<b>APPLICATION NO</b>	<b>PA/2017/1937</b>
<b>APPLICANT</b>	Corcoran, The Money Box
<b>DEVELOPMENT</b>	Advertisement consent to retain two non-illuminated fascia signs
<b>LOCATION</b>	1-2 Market Place, Barton upon Humber, DN18 5DA
<b>PARISH</b>	Barton upon Humber
<b>WARD</b>	Barton
<b>CASE OFFICER</b>	Scott Jackson
<b>SUMMARY RECOMMENDATION</b>	<b>Refuse consent</b>
<b>REASONS FOR REFERENCE TO COMMITTEE</b>	Significant public interest

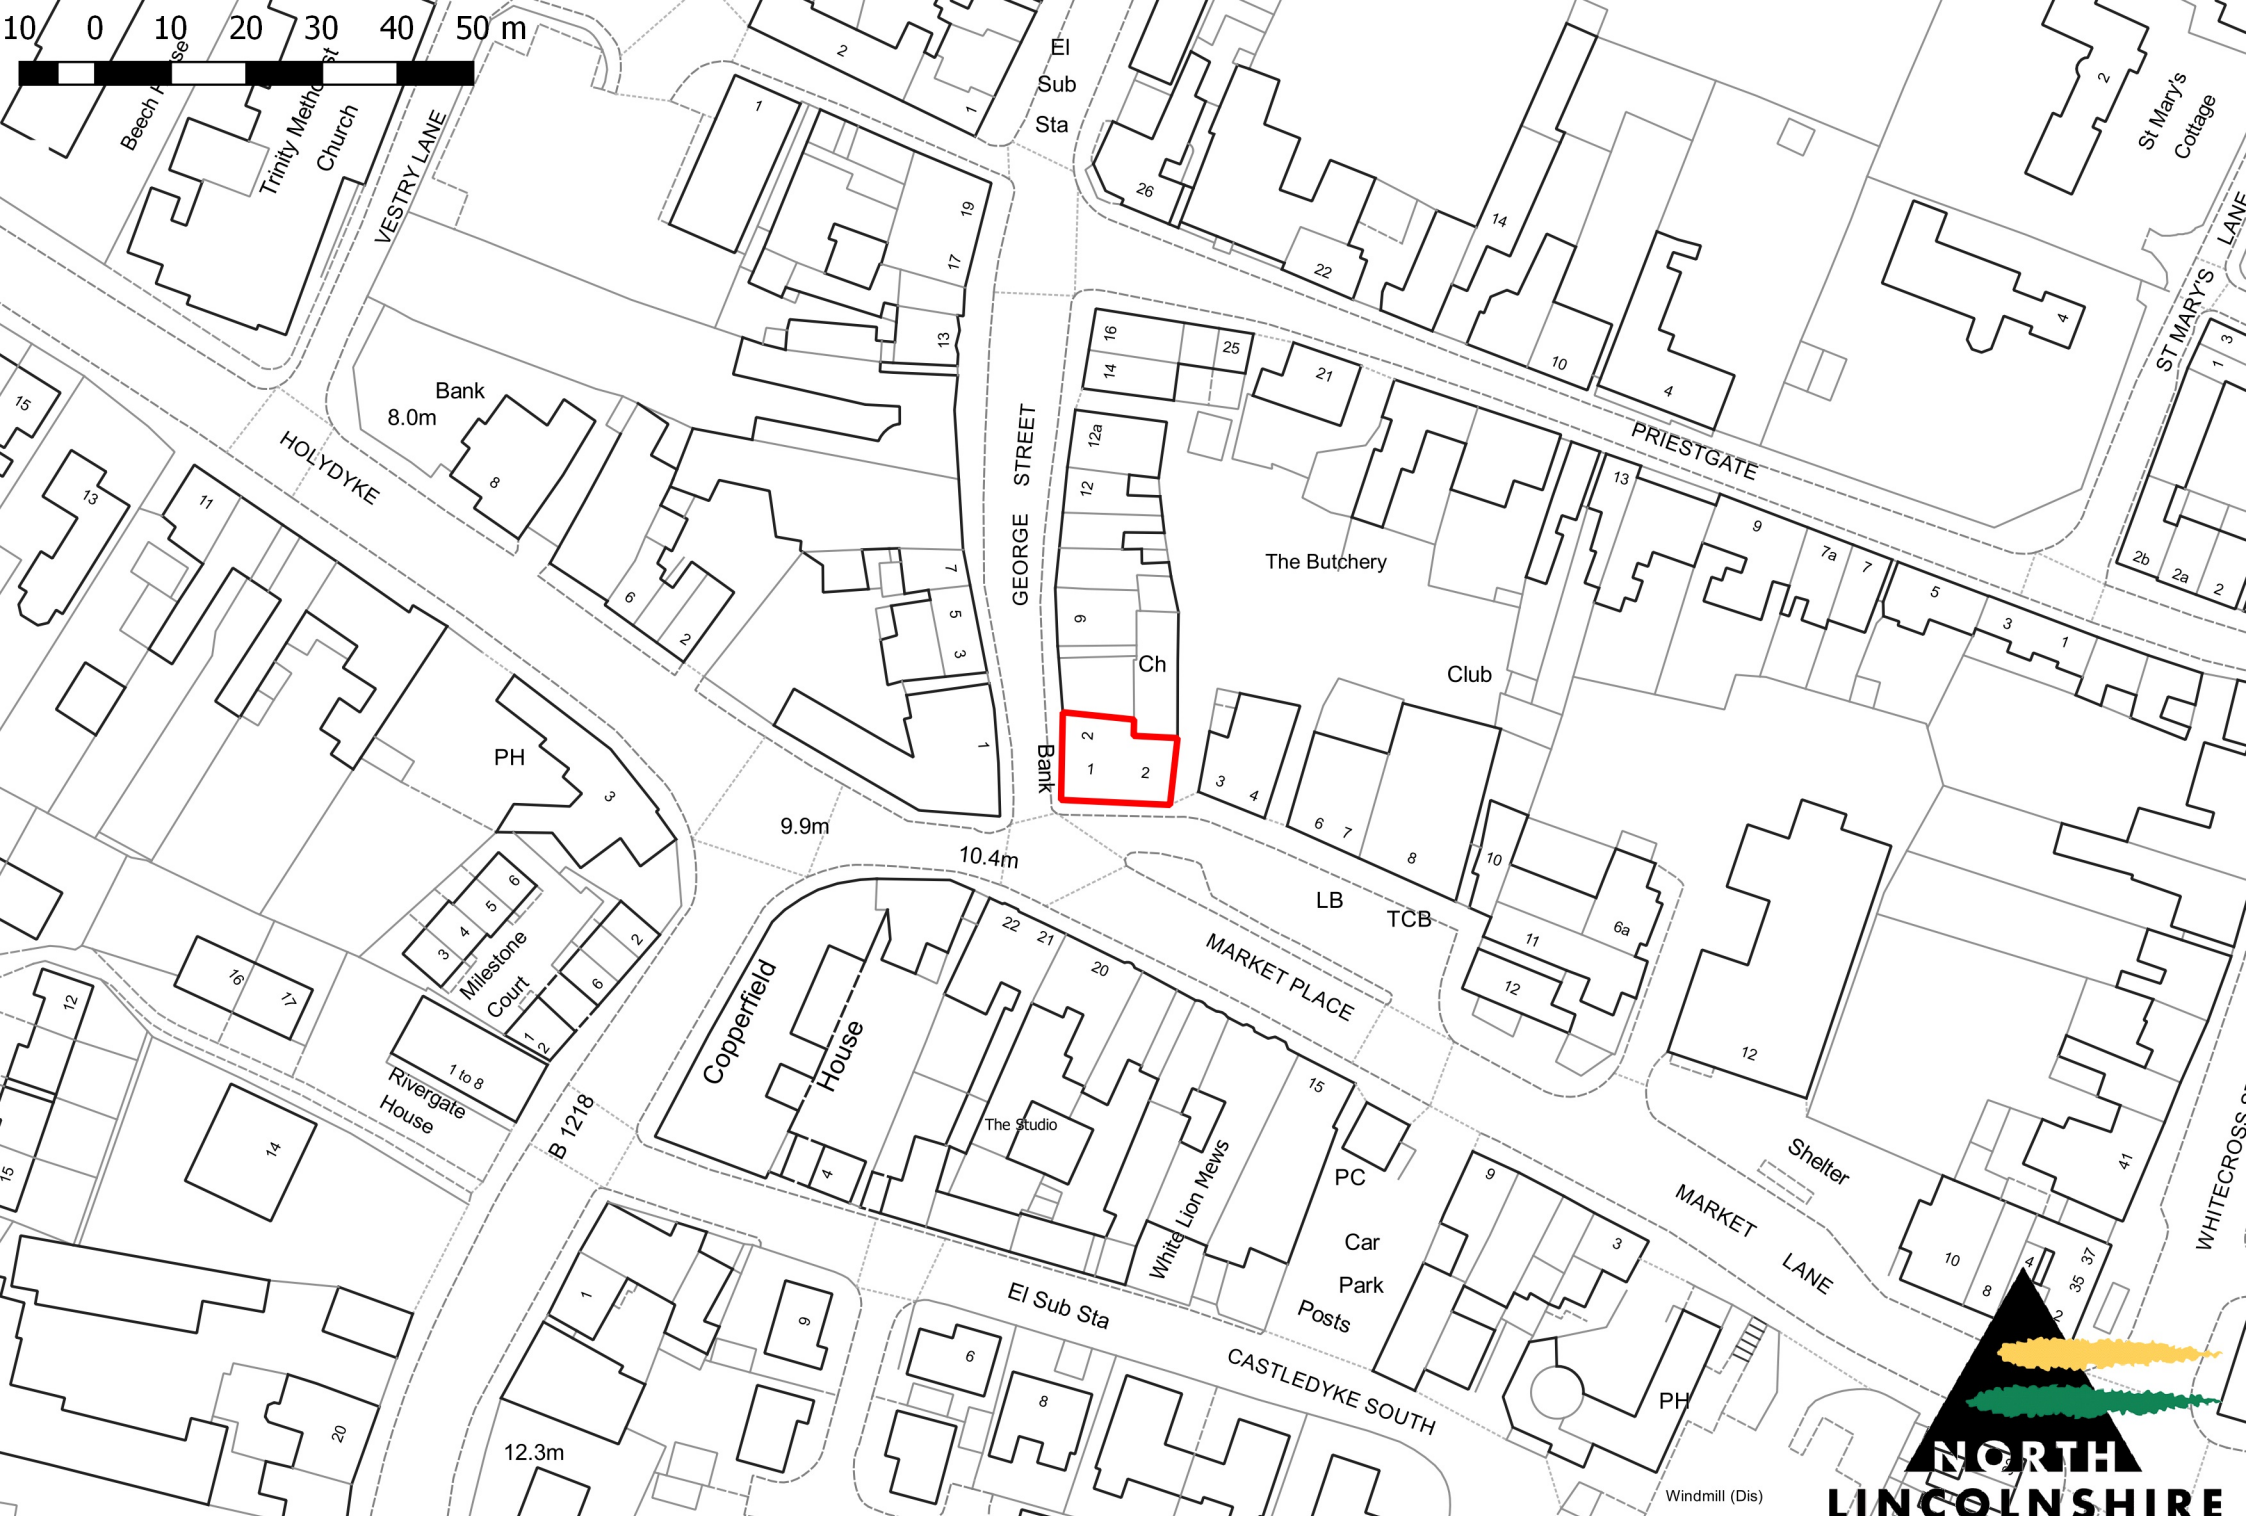
**Conservation Officer:** Objects on the grounds that it constitutes excessive signage that detracts from the character of townscape merit building in the Barton Conservation Area, the adjacent listed buildings in the Market Place and Barton Conservation Area.

The proposal is to retain two fascia signs on the Market Place and George Street frontage of this former Nat West bank building, in the conservation area. These signs consist of two fascia signs which are positioned above the ground floor windows and they span the entirety of the frontages facing both Market Place and George Street. The adverts are constructed from alupanel which is of composite aluminium construction and features predominantly white lettering on a blue background which spans the entirety of the fascia sign; this results in two visually prominent signs in the conservation area. These signs are visually prominent on the former bank building (owing to its position on the corner of George Street and Market Place) and the scale of the lettering (in particular the company name) is disproportionate to the height and width of the fascia board on which they are positioned; this results in the signage being at odds with the architectural detailing and appearance of the building and therefore is considered to harm the character, appearance and setting of heritage assets.

This building is identified in the Barton conservation area appraisal and supplementary planning guidance as a Building of Townscape Merit; these are unlisted buildings which are considered to positively contribute towards the character and appearance of the conservation area. The signage and writing on the fascia board wraps around the entire frontage of the building and therefore gives the appearance of a continuous advert which is cluttered and visually dominant to the detriment of the character and appearance of the building and the Barton conservation area. It is worth noting that the sign which previously adorned this building was much simpler in its proportions and scale and wasn't considered to jar with the architectural quality of the building and wasn't out of keeping with the character and appearance of the conservation area. The retention of the advertisements is not considered to comply with policies HE2 and HE4 of the North Lincolnshire Local Plan.

The advertisements by virtue of their position across the entire frontage of the building, scale and size of lettering are considered to result in a visually prominent and discordant feature. The advertisements, due to their scale and extent and size of lettering gives the appearance of a continuous fascia sign which dominates views into the Barton conservation area and results in unnecessary clutter to the principal elevations of this former bank to the detriments of the appearance and architectural features of this Building of Townscape Merit and which detracts from the character, appearance and setting of heritage assets in this part of Barton. Accordingly the retention of the advertisements is considered to be contrary to policies HE2 and HE4 of the North Lincolnshire Local Plan.
